ASB-1002

Service Bulletin

Subject: TS-450/690 Distorted TX w/TNC

Date: November 18, 1992

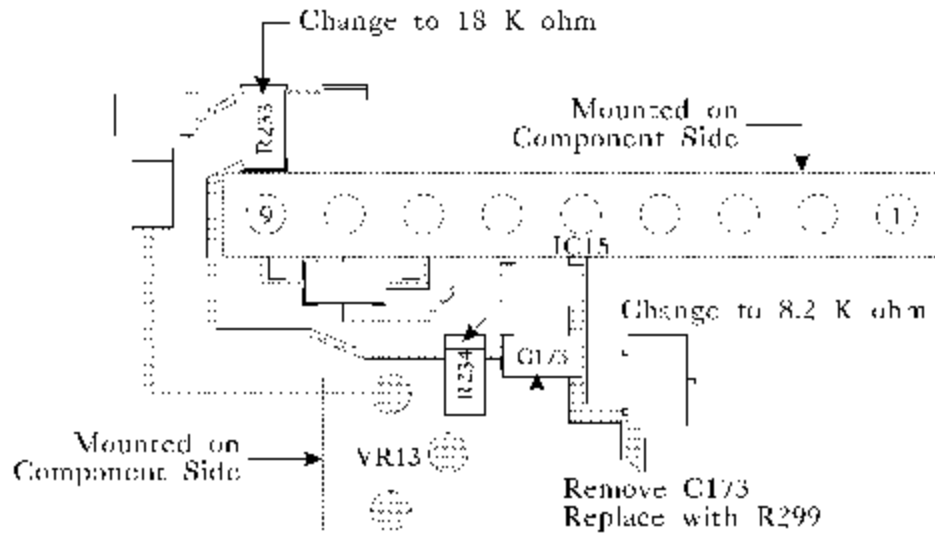
Don't make initial ALC adjustments for Packet, etc. over this level. Adjust higher only if you can do this without distortion.

Part of IF Unit X48-3090-XX Foil Side View

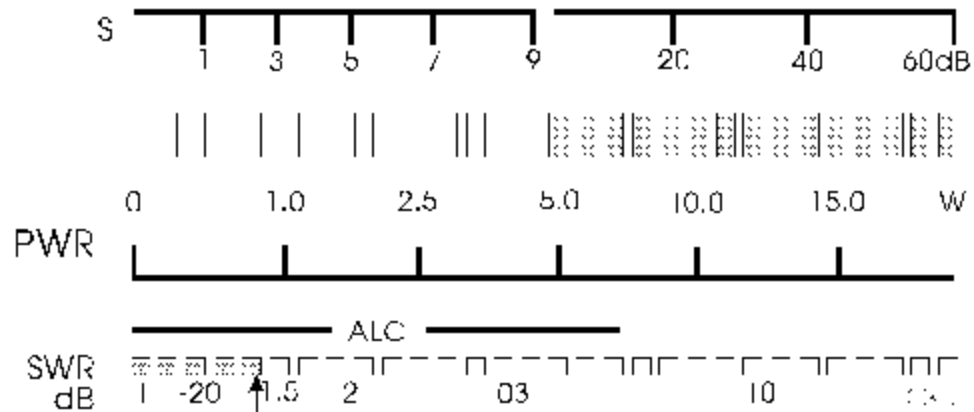
Cause: The audio output level from the TNC is generally too high and causes overload of the microphone amplifier circuit. In previous models such as the TS-440S the incoming TNC audio was inserted after the microphone amplifier. With the TS-450/690S it is inserted before the microphone amplifier. Just moving the insertion point to the output of the circuit is not satisfactory since the drive level for FM packet is higher than that required for SSB.

1. Add a 10 db attenuator to the PKD line on the IF unit (X48-3090-XX). This will prevent overmodulation of the microphone input circuit.
 - a. Change chip resistor R233 from 10K to 18K ohms (RK73FB2A183J)
 - b. Change chip resistor R234 from 1K to 8.2K ohms (RK73FB2A822J).
 - c. Delete chip capacitor C173 (100pF) and add chip resistor R299, 1.5K ohm (RK73FB2A152J)
2. Add the following note to page 35 and 37 of the Instruction manual.
3. When adjusting for proper ALC levels with an AFSK RTTY terminal or Packet TNC terminal you should adjust VR-13 on the IF Unit for a reading similar to the one shown in the accompanying diagrams.
